Service Bulletin

Bulletin No.: 22-NA-198

Subject: Information on Dimpling of Front Fascia Due to Incorrect Front Splitter Fasteners Installed at PDI

Brand:	Model:	Model Year:		VIN:		Engine:	Transmission:
		from	to	from	to		
Chevrolet	Corvette Z06	2023	2023	—	—	—	—

6163500

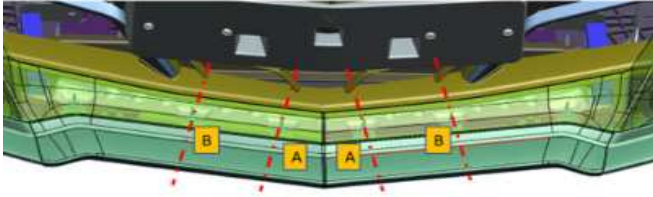
During the installation of the front splitter kit, it is important to install using the correct fasteners.

There are four long fasteners included in the front splitter kit. They should **NOT** be used due to the longer fasteners possibly creating a dimple on the front fascia.

Fasteners A and B — Should use part number 11547755

Important: There will be 4 extra bolts of Part Number 11589012 in the original hardware kit after performing installation. These bolts can be discarded.
